IN THE DRAWINGS

POLYMER PLACEMENT SITE 1
10/018,302
U 013688-5

FIG. 5

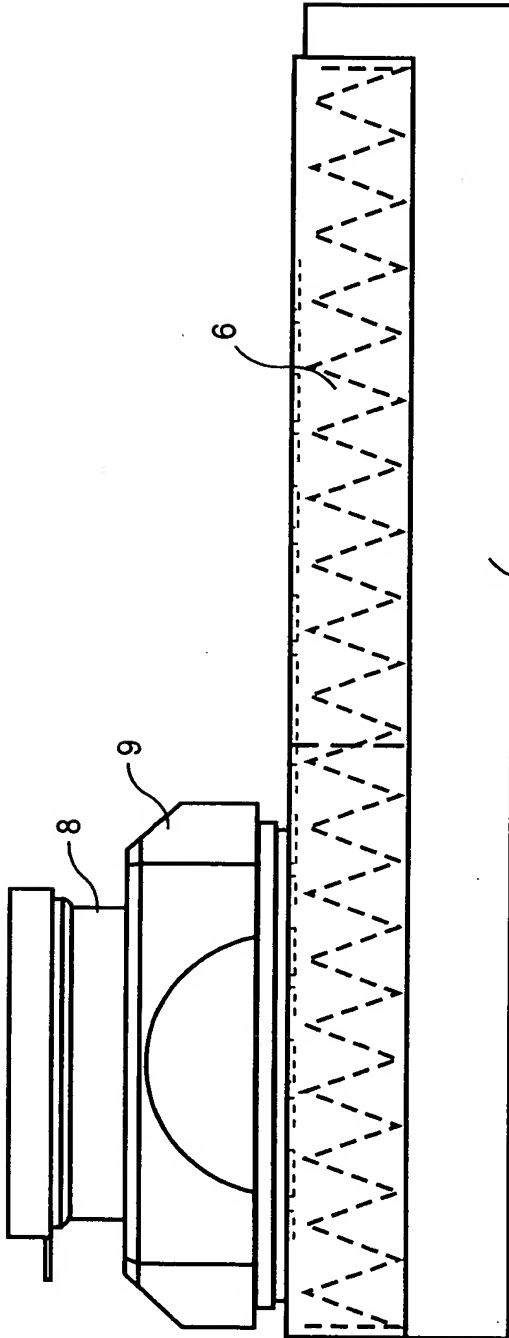
In Figs. 5-11, members 6, 7, 9, 8, 7, 10 and 6, respectively, were originally shaded to indicate heating. On the attached replacement sheets of these Figs. the shading is replaced zig-zag phantom lines that may suggest heating by zig-zag resemblance to electrical resistance but do not introduce such electrical resistance because in phantom lines.

FIG. 9

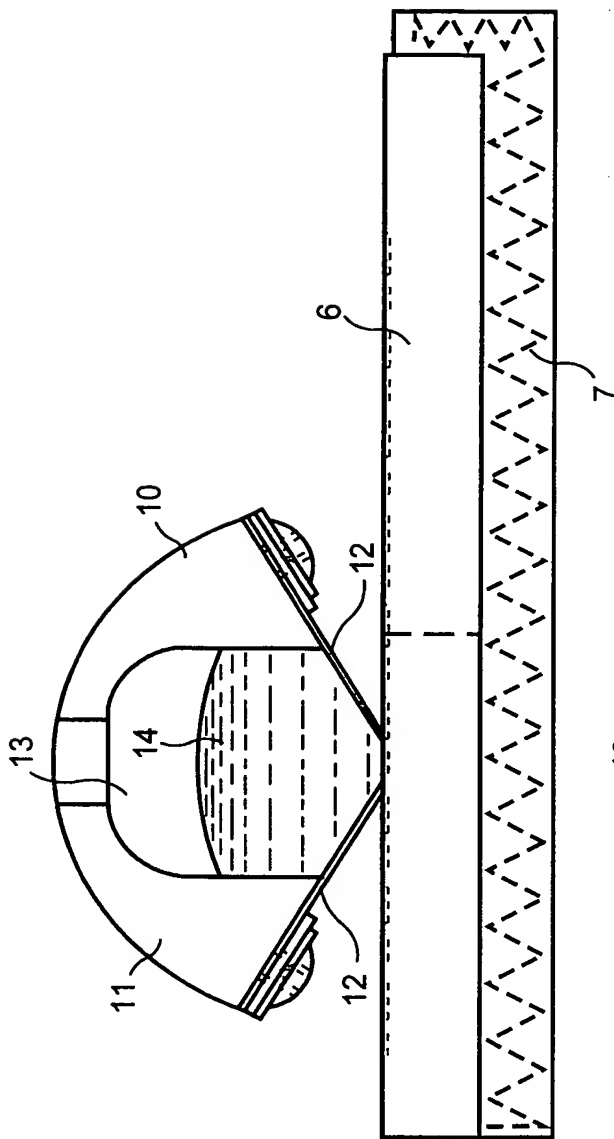
In Figs. 9-11, more familiar liquid-indicating shading is used for ink 14.
